## ADDENDUM #5

**Western Slope Food Bank of the Rockies**  
698 Long Acre Drive

**Bid Package #4 – Above Ground**

September 10, 2021

PROJECT NO: **A141**  
2108

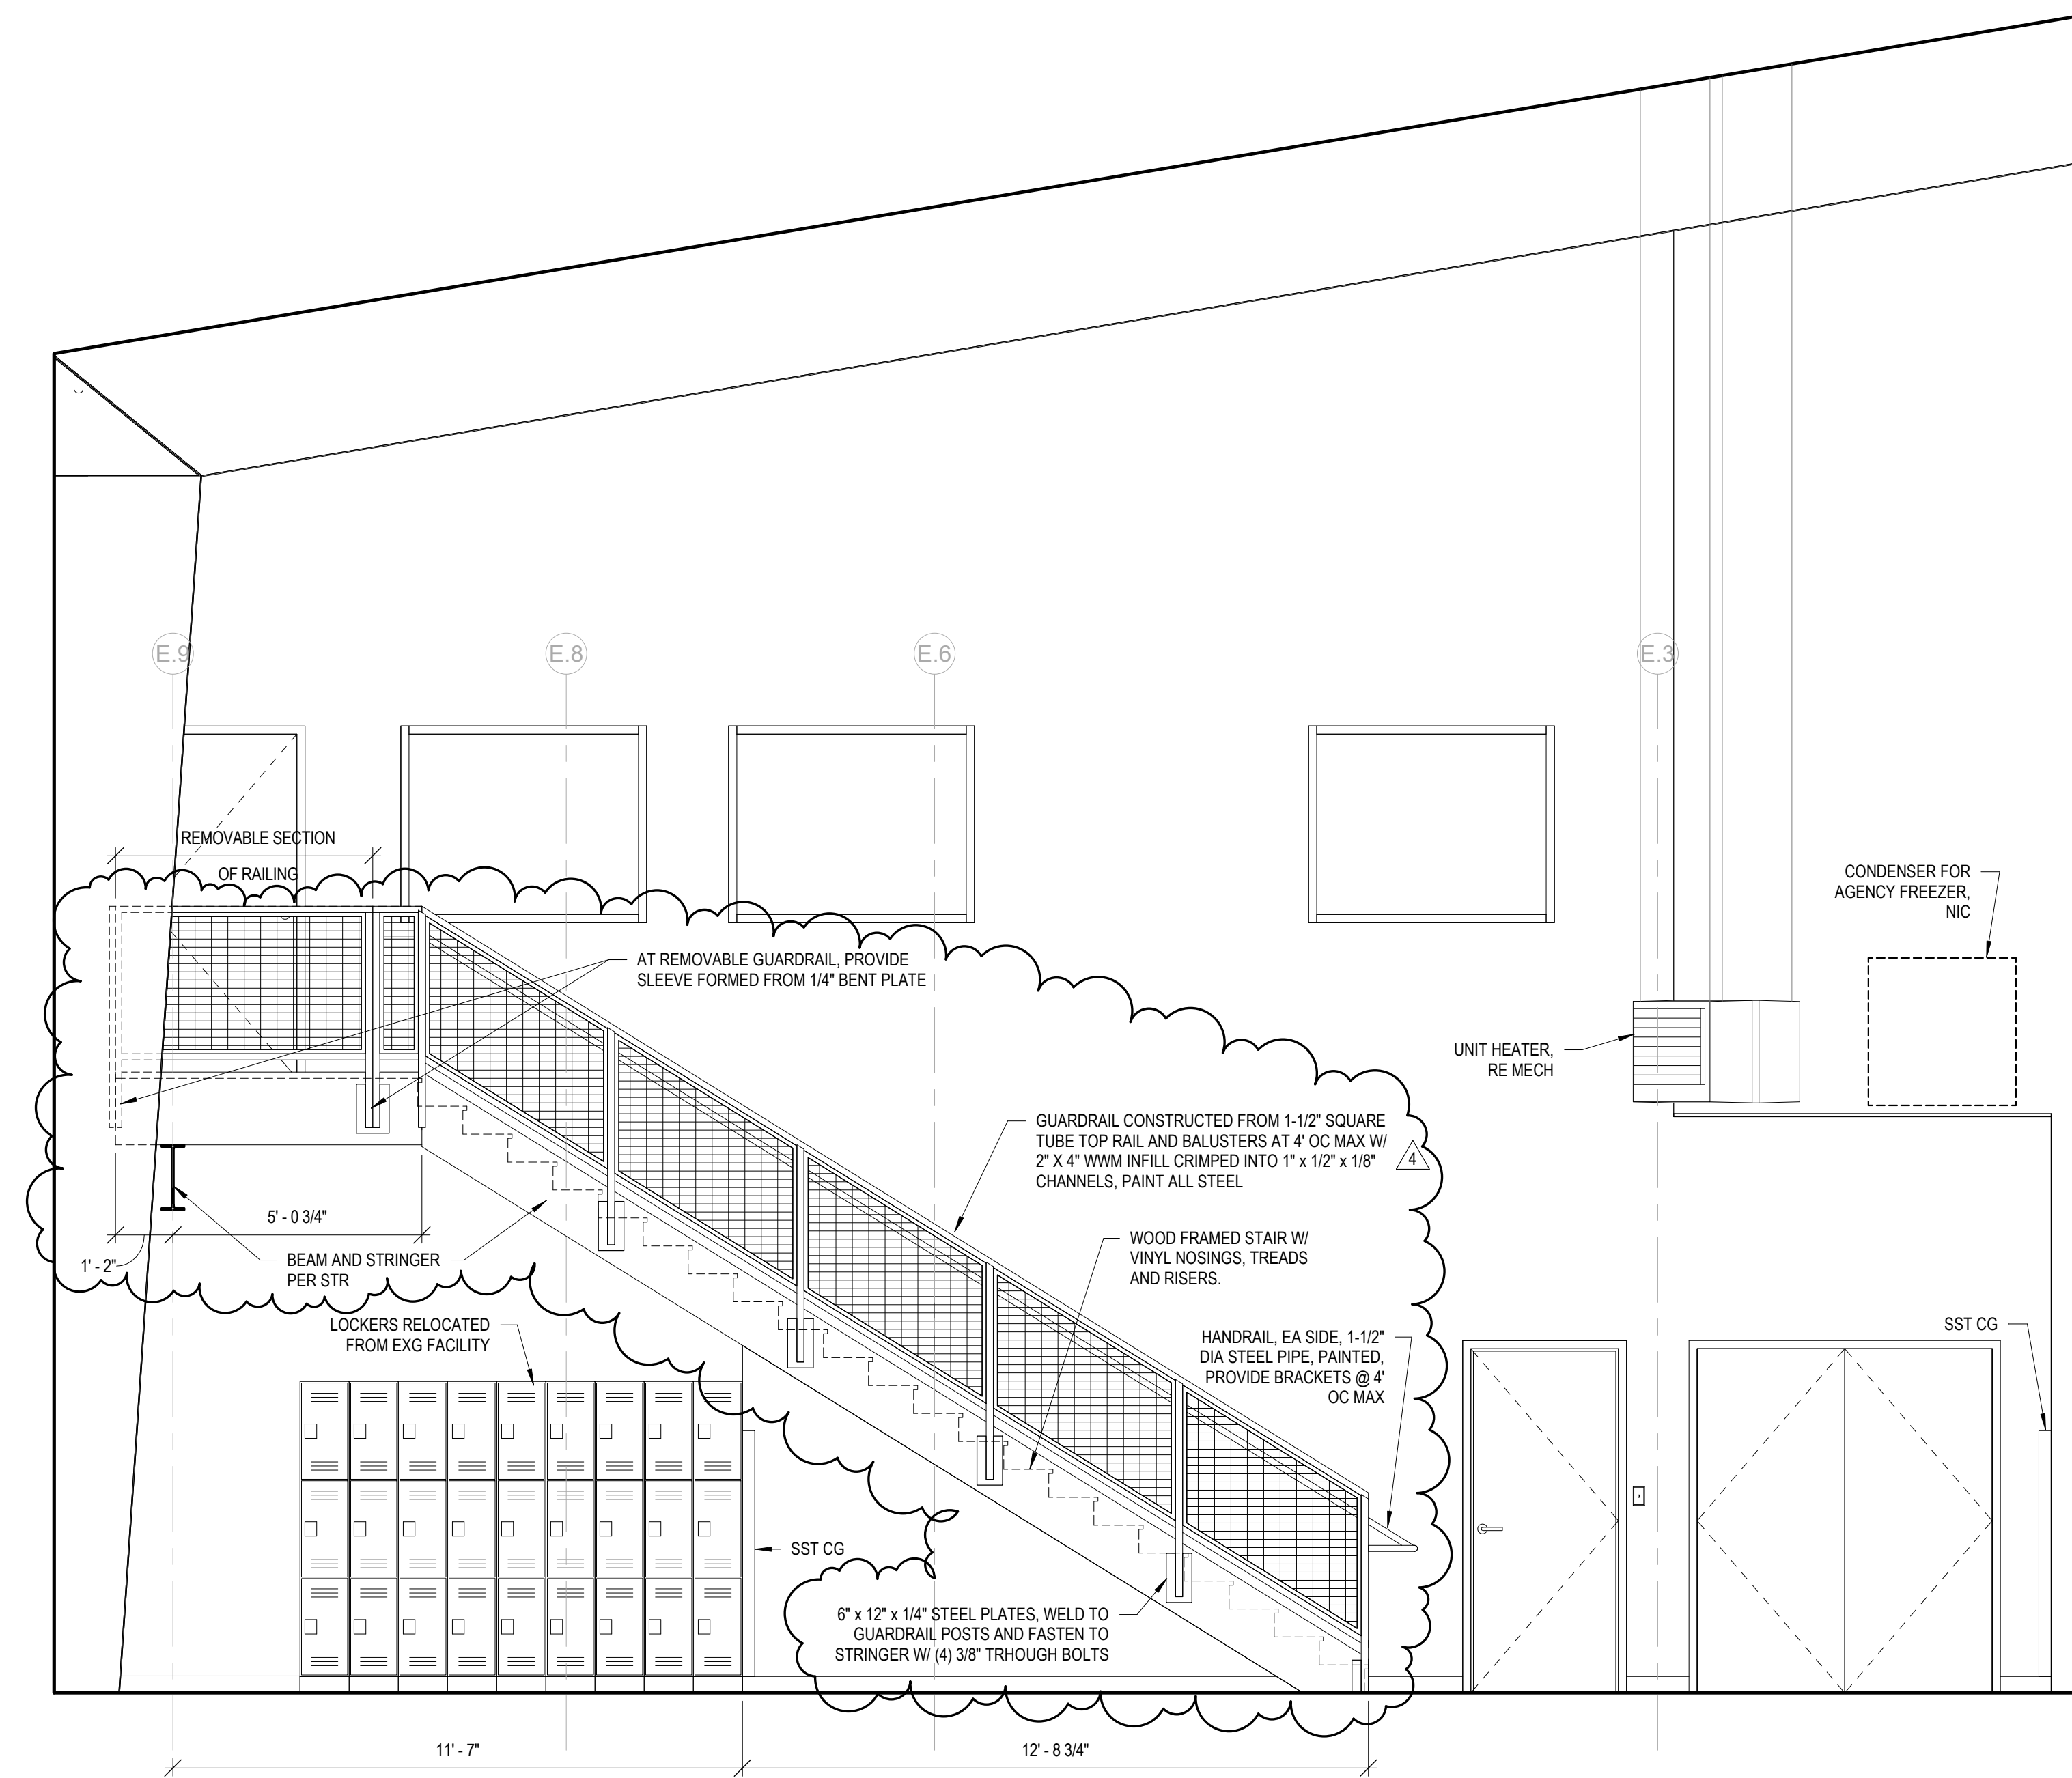
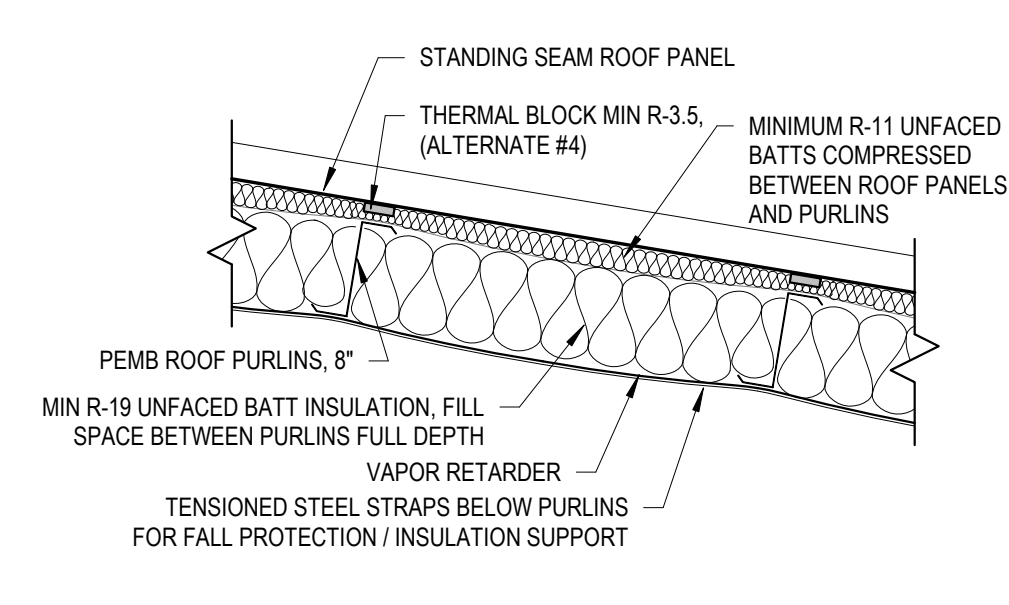
- ADD5-14 Sheet A141 Roof Plan: Add attic louvers per attached reissued sheet A141.
- ADD5-15 Sheets A161 and A162, Interior Finish Legend: Under Floor Finishes, change SCONC – “Sealed Concrete” to  
SCONC - CONCRETE FINISHED WITH CURE-  
DENSIFIER-HARDER PER 033500.

- LOUVERS SHOWN ON ENLARGED ROOF PLAN ARE FOR VENTING OF ATTIC AND INCLUDE ONE TALLER LOUVER WITH A HINGED DOOR AND LOCK FOR ATTIC ACCESS. THESE LOUVERS SHALL BE DRAINABLE AND DESIGNED TO RESIST WATER PENETRATION. PROVIDE INSECT SCREENS AND MEET SPECIFICATIONS OF SECTION 230701. ALL ATTIC VENTILATIONS LOUVERS ARE APPROXIMATE 22" WIDE, SIZED AND LOCATED TO FIT BETWEEN ROOF FRAMING MEMBERS. FINAL DETERMINATION OF LOUVER SIZE SHALL ALLOW FOR A TOTAL NET FREE VENTING AREA OF 16.8 SF. SPACE (4 LOUVERS) APPROXIMATELY EQUALLY ACROSS WEST WALL WITH (1) EACH ON THE NORTH AND SOUTH WALLS OF THE RTU AREA.

2. Alternate: Add thermal blocks under roof panels, minimum R-3.5, refer to detail for Typical Roof Assembly at PEMB, on A141.

ROOF ASSEMBLY AS DETAILLED  
WITHOUT THERMAL BLOCK (BASE BID) U-0.040  
WITH THERMAL BLOCK (ALTERNATE #4) U-0.035
